September 28, 2026 NWB File No. 2AM-WTP1830

Re: Water Licence 2AM-WTP1830 – 2026 Whale Tail Waste Rock Storage Facility Modification

Attachment E WRSF Design

Figure 1: Approved Whale Tail Mine and Whale Tail WRSF Modification

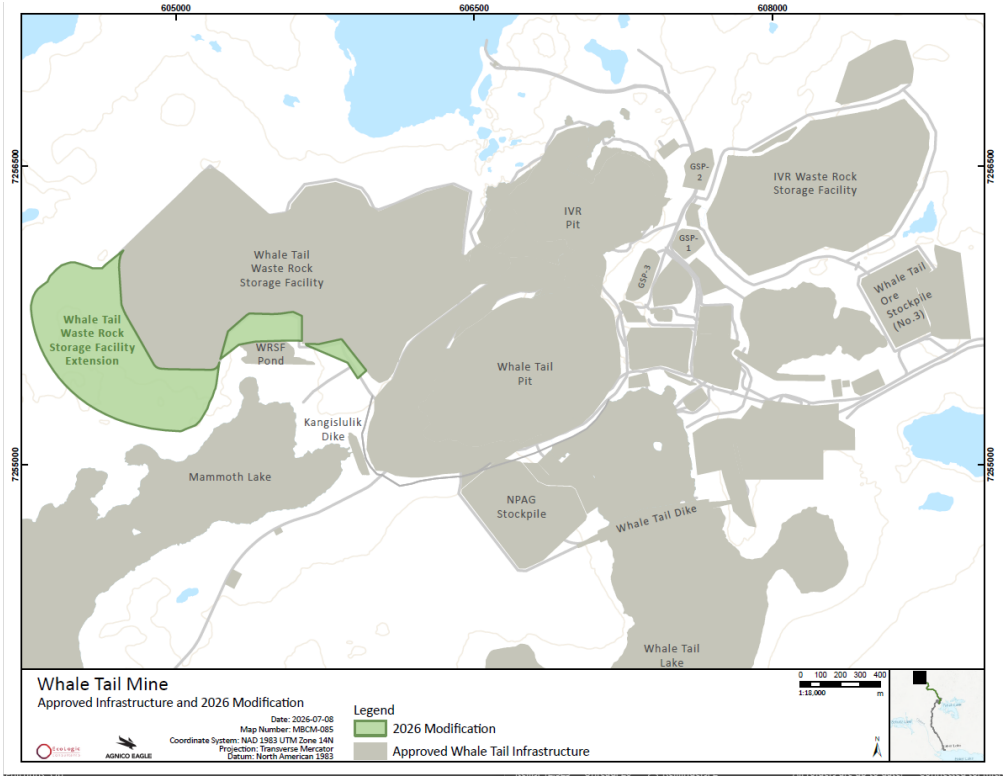
The proposed modification to the Whale Tail WRSF is to accommodate waste production from the mining of Whale Tail Pit. Agnico Eagle has determined with continuing to mine the approved Whale Tail pushback that the approved Whale Tail WRSF cannot accommodate all the waste rock generated. The modification of the WRSF will have the capacity to hold 90M tonnes of waste rock. All runoff from the WRSF will be routed to the existing WRSF Pond and pumped to the attenuation pond, as per current process. Review of updates to water management infrastructure to design criteria is currently in progress; if updates are needed for freshet 2027, design reports will be submitted.

Activities for the WRSF Modification are located within the approved Whale Tail Mine footprint (Project Certificate No.008, Amendment 001), as presented in Figure 1.

MEADOWBANK DIVISION
ENGINEERING
WHL_WRSF_V08

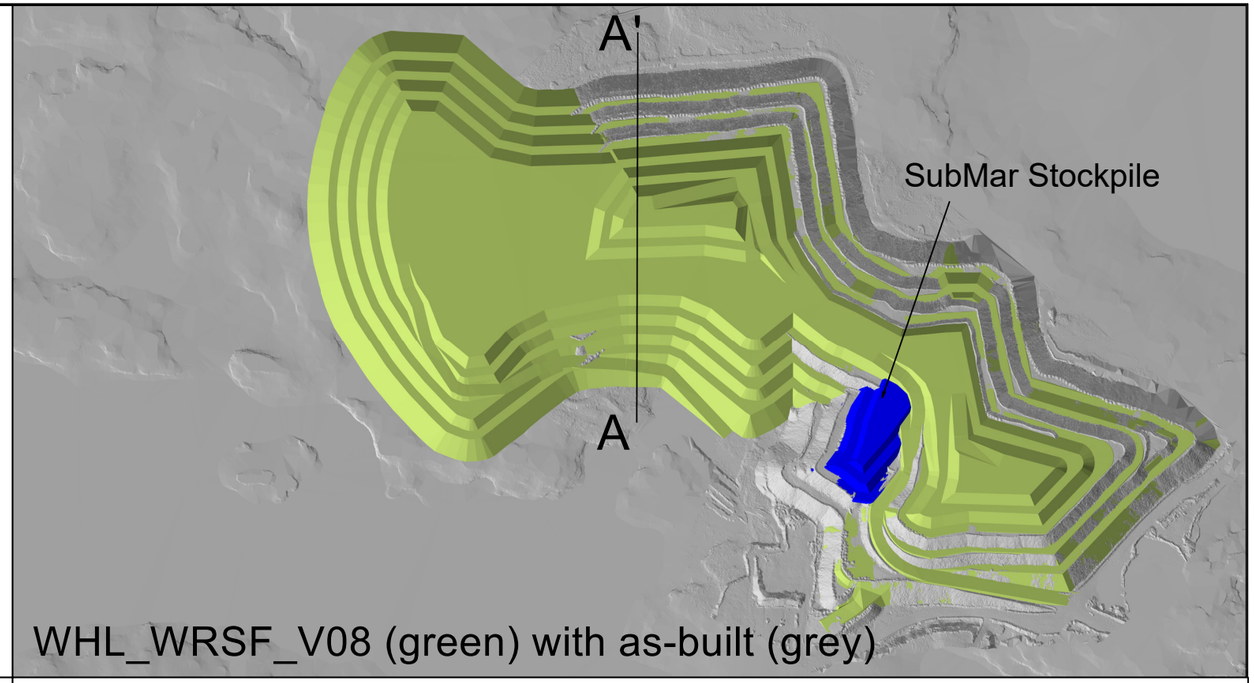
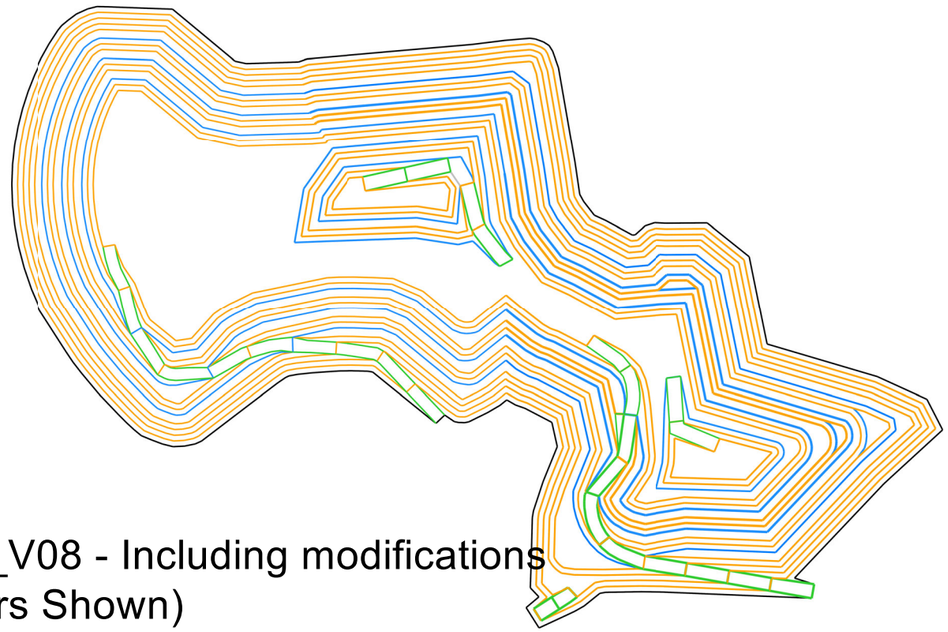
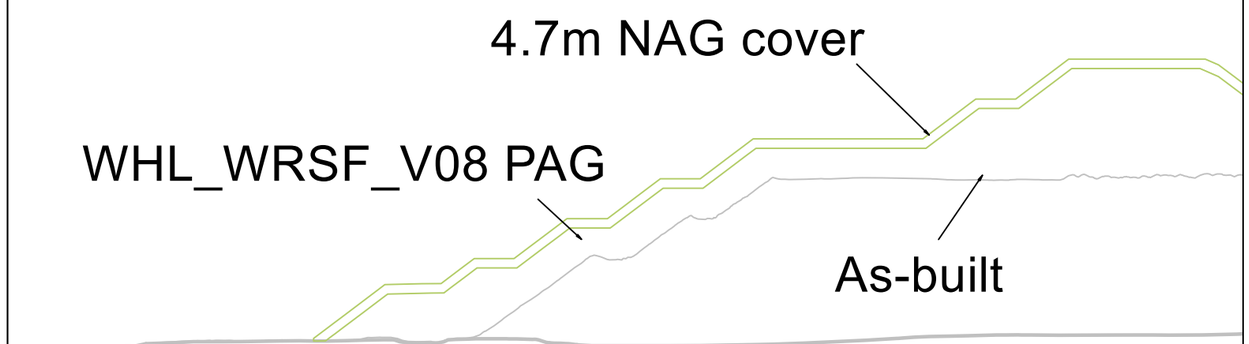
Modification to the Whale Tail WRSF will follow the same Design Report and Drawings submitted in December 2019 (Agnico Eagle 2019) and accepted by the NWB, per Part D, Item 4 of Water Licence 2AM-WTP1830. As per the drawing in Attachment E, there will be a modification to the facility to accommodate the waste rock.

WHL_WRSF_V07C - Current Design
(NAG Contours Shown)

WHL_WRSF_V08 (green) with as-built (grey)

WHL_WRSF_V08 - Including modifications
(NAG Contours Shown)

WHL_WRSF_V08 VOLUME: 95.7M m³ PAG, 8.3M m³ NAG
WHL_WRSF_V08 TONNAGE CAPACITY: 197.0Mt PAG, 17.2Mt NAG
